## External Technical Review Remedial System Performance Improvement for the 200-ZP-1/PW-1 Operable Units at Hanford

# **Review Report: Feasibility Study Strategies and Remedial System Performance Improvement for the 200- ZP-1/PW-1 Operable Units at Hanford**

February 9, 2007

Figure 3 1. 200-ZP-1 Operable Unit Interim Remedial Operation Phase III Pump and Treat Design Process Flow Diagram.

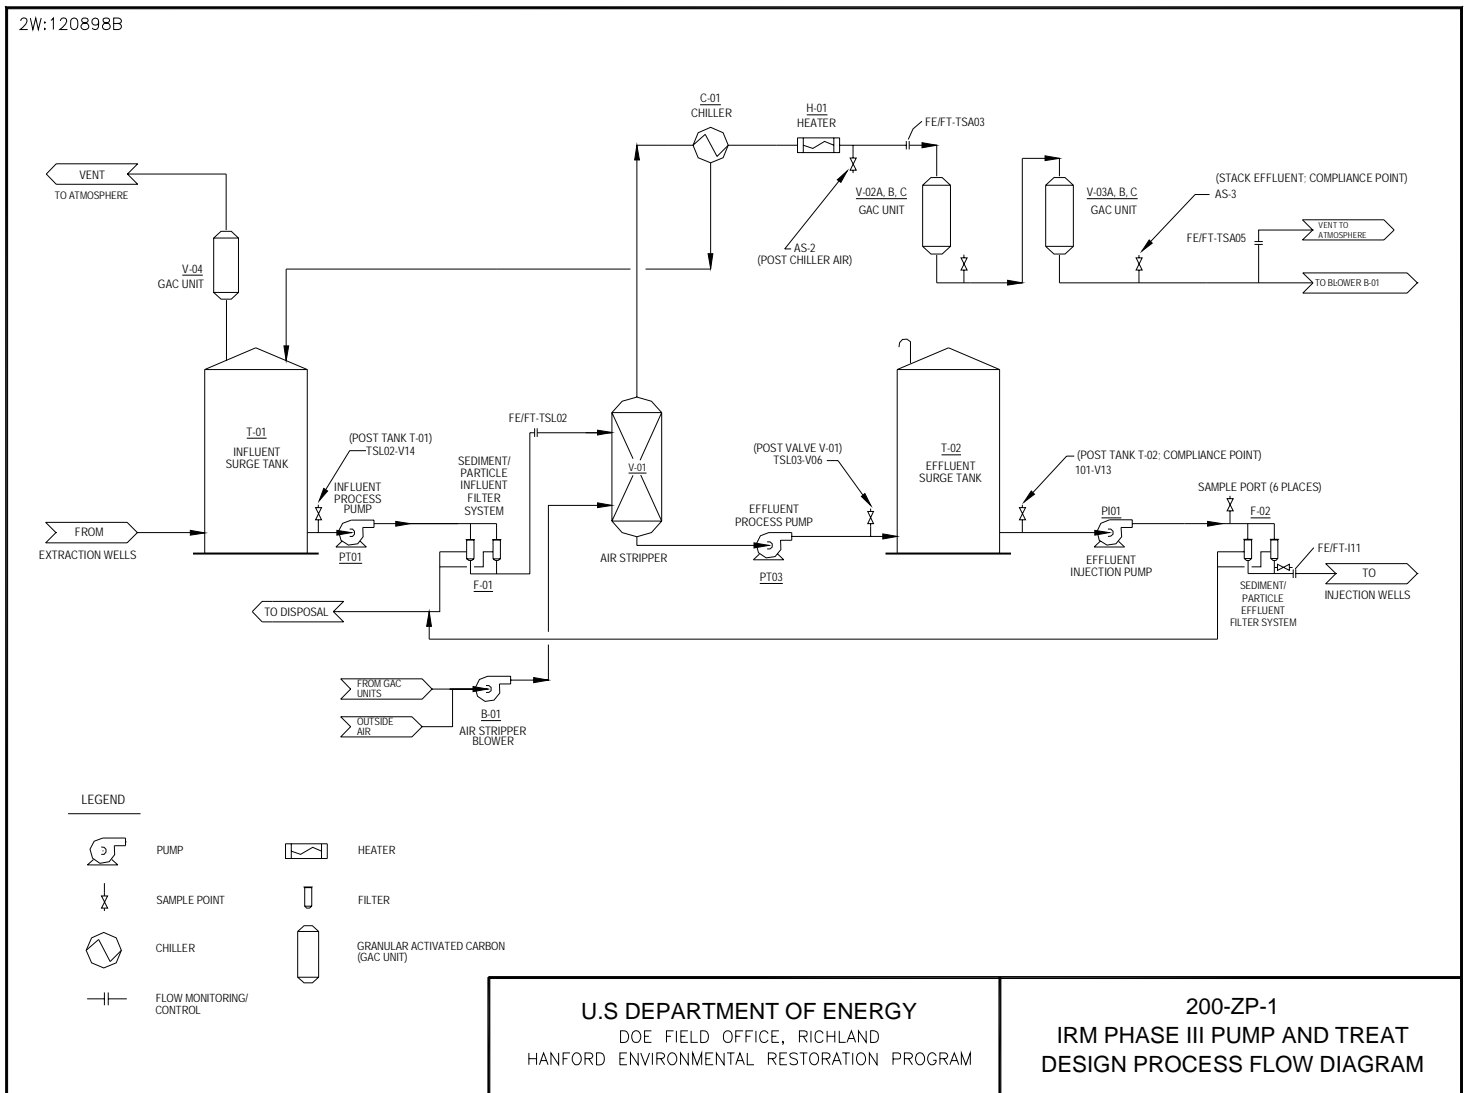
The ZP-1 treatment system at Hanford is generally well run and maintained. The operators are knowledgeable and have a strong dedication to maintaining and improving the system. The ZP-1 treatment process flow diagram is included in Figure 3-1. Flow to the plant is through seven pipe headers with four above-ground headers constructed of 3-inch-diameter high density polyethylene (HDPE), and the three below-grade pipe lines constructed of poly vinyl chloride (PVC). Below-grade piping is double-walled. Current flow rate to the plant is approximately 290 gpm, well below the plant capacity of 500 gpm. The design influent concentration is 6000  $\mu\text{g/L}$  CT.

Flow from the wells discharges to an influent surge tank (T-01), where it is pumped through 5 micron filters prior to passing through the 8-foot-diameter, 60-foot-tall packed-tower air stripping unit. Following treatment through the air stripper, the treated water is sent to an effluent surge tank (T-02). Water is pumped from T-02 to the injection well system following cartridge filtration. Off-gas from the air stripper is chilled to remove the moisture, and reheated to eliminate condensation as it is treated through vapor-phase GAC prior to discharge to the atmosphere. Monitoring of the individual GAC units and worker breathing space is done by an eight-channel continuous vapor sampler. A total of approximately 9,300 kg, or 20,460 pounds (lb) of CT has been removed.

Figure 5.1. Schematic illustrating suggested remedial approach

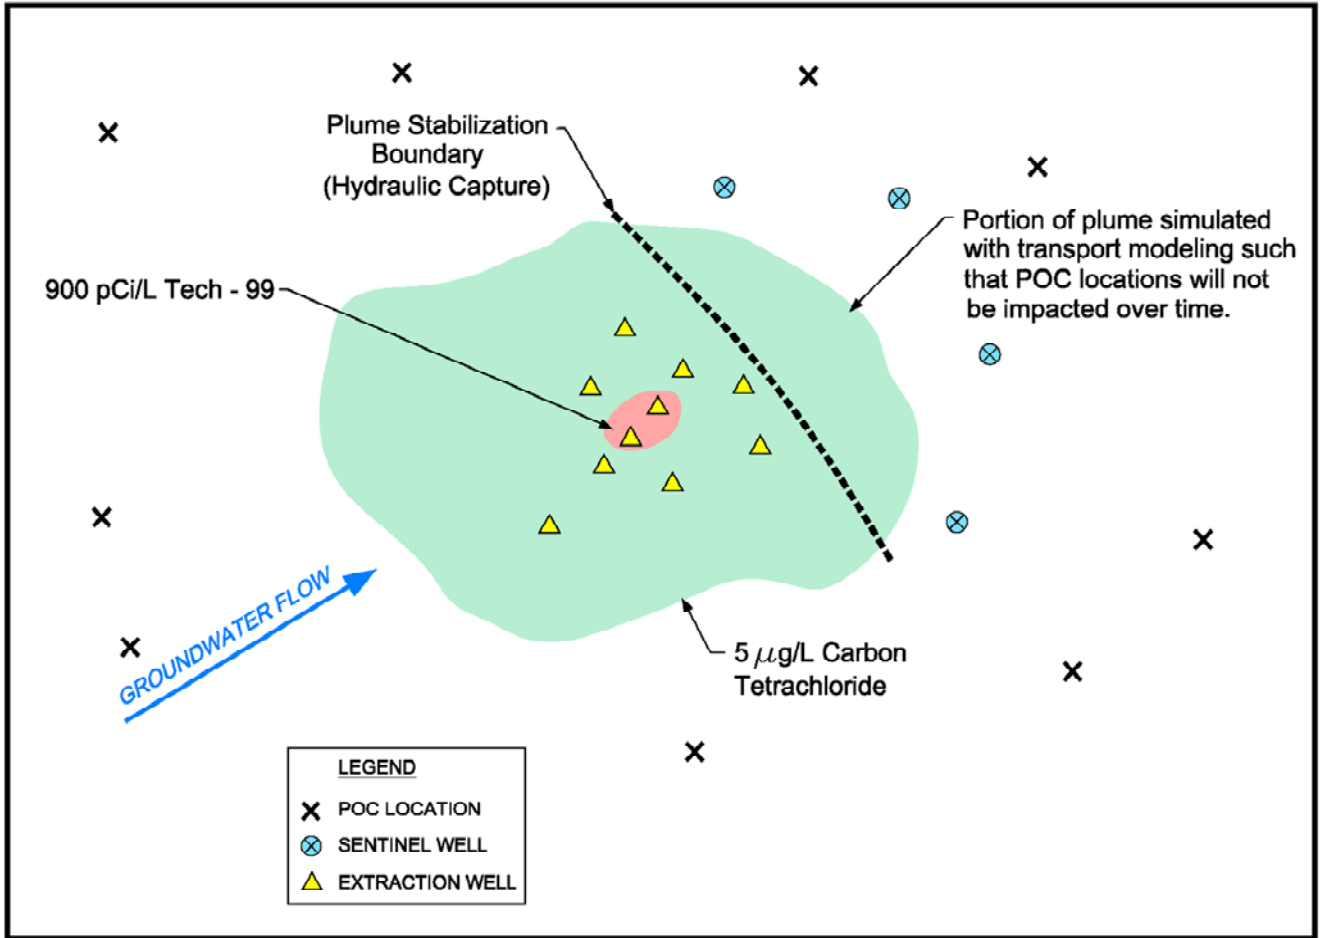
The FS may include consideration of several P&T approaches. For instance, one approach might include hydraulic containment for the full extent of the CT plume above cleanup levels. An alternate approach that may require much less capital and life-cycle cost is hydraulic containment of the most impacted portion of the CT plume, with natural remediation for the portion of the plume beyond the zone of hydraulic containment. This latter approach is schematically illustrated in Figure 5-1. The Review Team believes this latter approach will be evaluated favorably within the FS, to the extent that a combination of modeling and monitoring is incorporated to demonstrate long-term protectiveness at point of compliance (POC) locations.

Deciding on a specific boundary for the zone of hydraulic containment, the Target Capture Zone, will consider several factors:

- The Target Capture Zone should be located beyond any locations where potential DNAPL is suspected. In this manner, the groundwater downgradient from the zone of hydraulic containment should decrease in contaminant concentration over time by reducing source contribution through hydraulic containment.

As discussed in Section 5.2.3, one remedial approach favored by the Review Team is to use groundwater extraction for hydraulic containment of the most impacted portion of the CT plume, with natural remediation for the portion of the plume beyond the zone of hydraulic containment (schematically illustrated previously in Figure 5.1).
